INSPECTION REPORT

Inspection Date:	05/25/2021	
Time:	Entry: 9:00 a.m.	Exit: 12:00 p.m.
Weather:	Periodic overcast with evidence of recent heavy precipitation	
Media:	Clean Water Act (CWA)	
Regulatory Program:	CWA NPDES/Industrial Stormwater	
Permittee Name(s):	Clyde Companies (Sunroc Corporation)	
Permittee Addresses:	501 E. 41 st St, (Sunroc Corporation)	
Permittee City, State, Zip Code:	Garden City, ID 83714	
Facility Name:	Notus, Boise River Rd. Facility	
Facility Physical Location:	Dixie River Rd.	
	Latitude/Longitude	43.7206°, -116.8166°
City, State, Zip Code:	Caldwell, ID 83607	
Facility Contact(s):	Kevin Kalmbach, Pit Supervisor Phone: (208) 600-2763 Email: kkalmbach@sunroc.com	
County:	Canyon County, Idaho	
NPDES Permit:	2015 EPA Multi-Sector General Permit (MSGP)	
EPA Facility Identifier:	IDR053231	
Industrial Sector	Sector D: Asphalt Paving and Roofing Materials Sector J: Construction Sand and Gravel	
Subsector	D1 and J1

Photograph 22. View of unconsolidated and unstabilized sand and soil slopes immediately adjacent to the tributary of Center Point Canal.

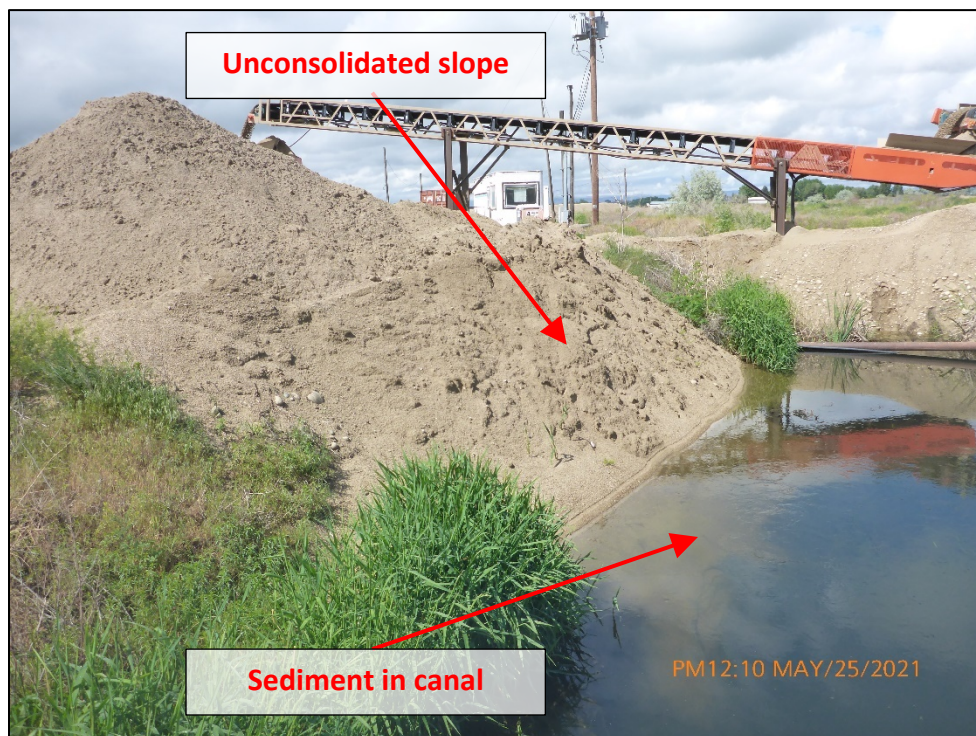
The Inspection Team observed large, unconsolidated and unstabilized slopes and berms of sand and soil immediately adjacent to the tributary of the Upper Center Pointe Canal that runs from east to west through the Facility. One slope of sand had eroded into the ditch (refer to Photographs 11, 22, 23, and 24). Section 3.1.1, Minimize Exposure, of the SWPPP states, "Overburden generated during the initial phases of mining will be used to construct topsoil berms along the perimeters of immediately adjacent properties, canals and irrigation ditches." Additionally, BMP #1 of Section 3.1.1 of the SWPPP states, "If berms are created in fine grained soil (topsoil) they should be re-vegetated to stabilize the berm from eroding."

- Area of Concern 2 – The Inspection Team observed large, unconsolidated and unstabilized slopes of sand and soil immediately adjacent to the unnamed irrigation ditch that receives discharges from the groundwater retention basin.

Exhibit 3. Close-up: SWPPP Site Map (denoted by red box on previous page). Yellow boxes highlight the two discharge points identified on the site map: "Outfall 001" and "Discharge 2".

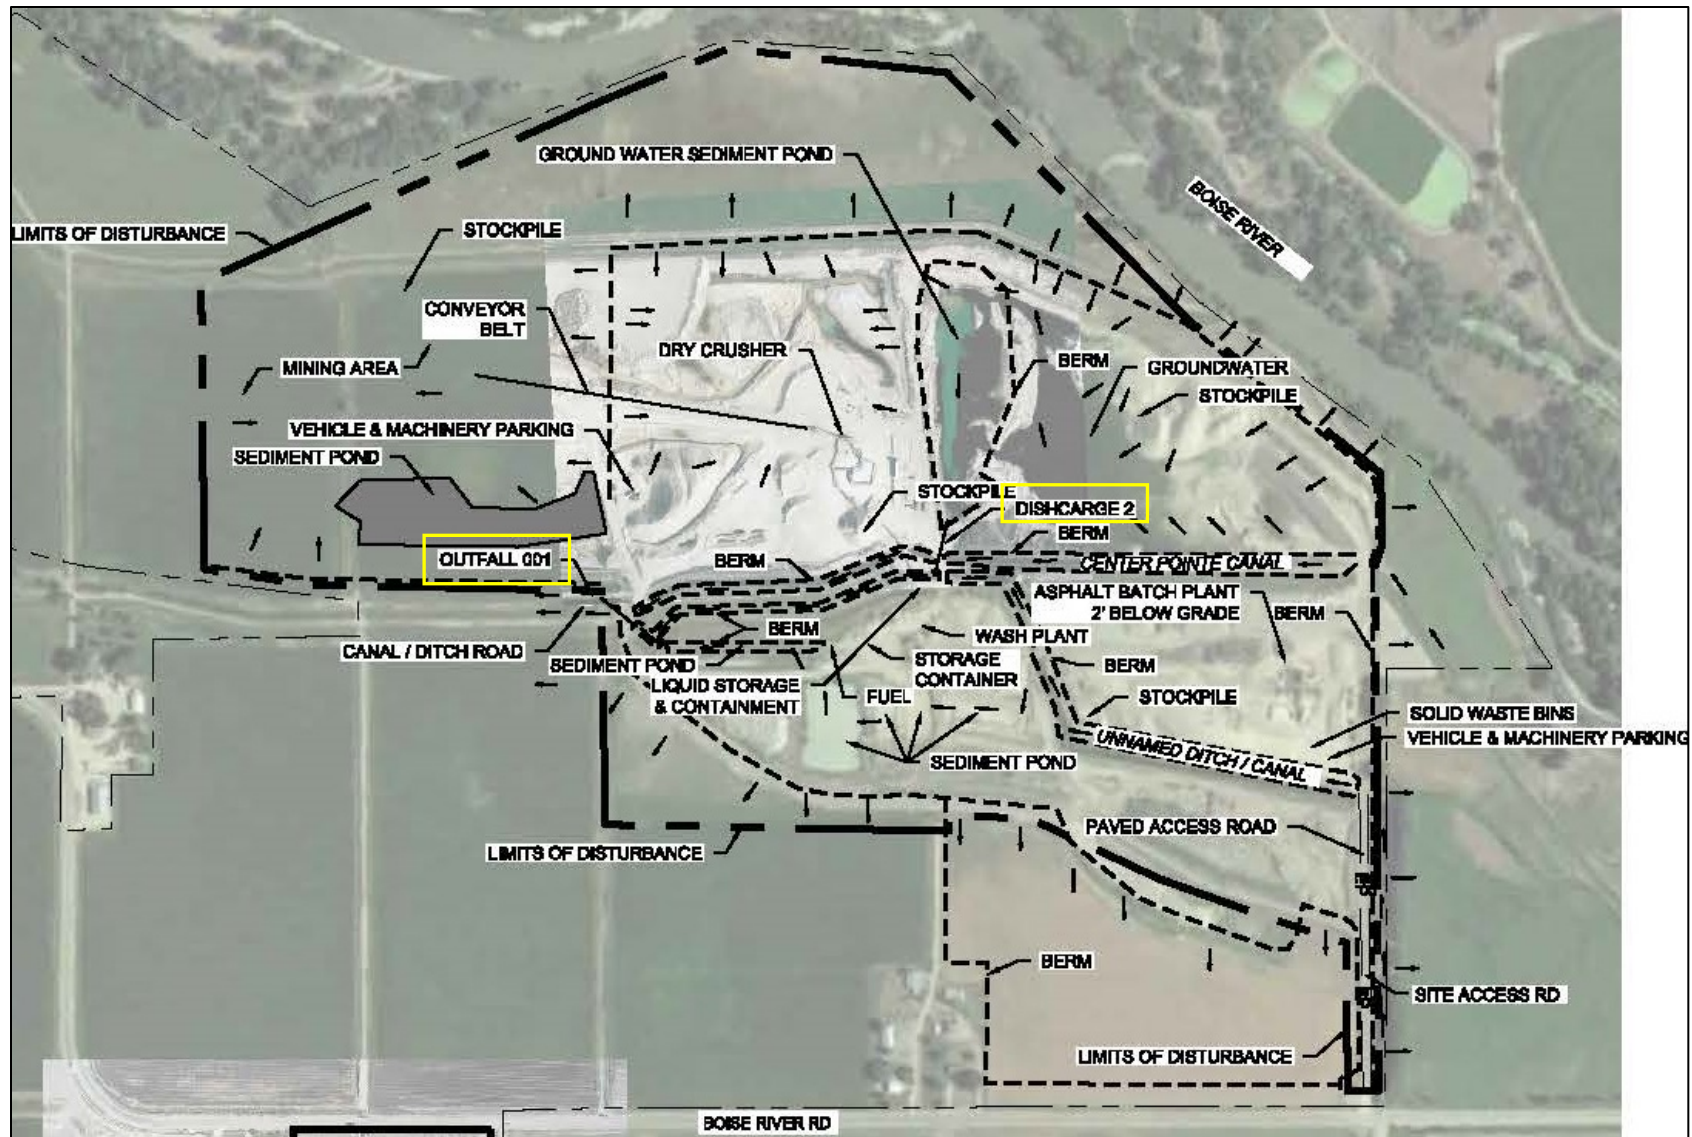
The SWPPP site map did not identify all stormwater discharge and monitoring points at the Facility. The Inspection Team noted that the SWPPP site map identifies two discharge points: 'Outfall 001' where the unnamed ditch leaves the property and 'Discharge 2' (refer to Exhibit 3). These points were indicated by an arrow pointing near where the two pipes from the groundwater retention basin discharge into the unnamed irrigation ditch, which was observed during the Facility walk-through. While it was unclear which discharge point was indicated by 'Discharge 2', the Inspection Team noted that at least one of the two discharge points was not identified on the site map. The site map also does not indicate whether Outfall 001 or Discharge 2 is a stormwater monitoring point. As stated above, the Permittee conducts sampling at the downstream discharge pipe (main discharge point) into the unnamed ditch (refer to Photographs 12 and 13).

Exhibit 4. Page 4 of 4. May 15, 2020 Stormwater Industrial Routine Facility Inspection Report (Quarterly). Inspection report notes that the newly identified discharge point above "dis. #1" needed to be added to the SWPPP; however, it was clear if "Discharge 2" identified on the SWPPP site map (refer to Exhibit 3) was this discharge point.
